Project Name: Washington Realtors BuildingMaster File: 16-9076

Date: April 24, 2017

CITY OF OLYMPIA
BASIC COMMERCIAL DESIGN CRITERIA
Chapter 18.110

CITY OF OLYMPIA
COMMERCIAL DESIGN CRITERIA-DOWNTOWN
Chapter 18.120

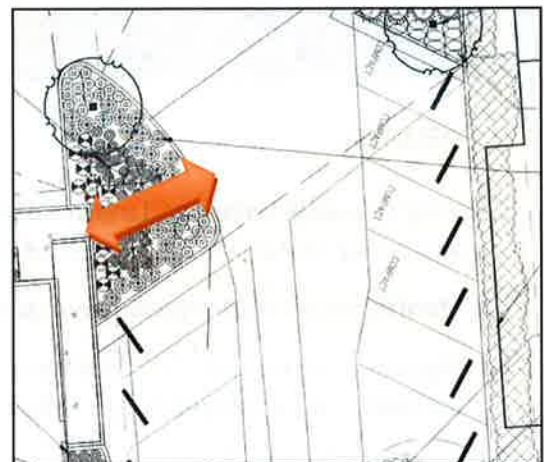
Original Comments: Pedestrian access between the parking lot and building entrances is provided. Improved access from the diagonal stalls on the east side of the building can be achieved by providing a walkway through the planting bed at the northeast building corner (see arrow).

Update Comments: A pedestrian walkway has been added to the site plan.

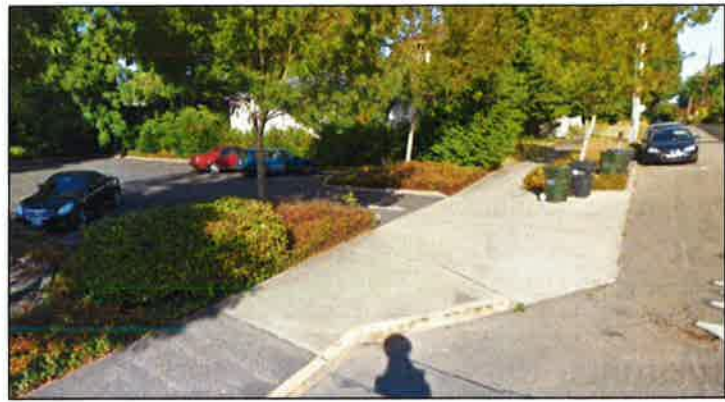
A portion of the frontage was reconstructed in conjunction with the DES building; these improvements provide visual continuity (see photo) to the south.
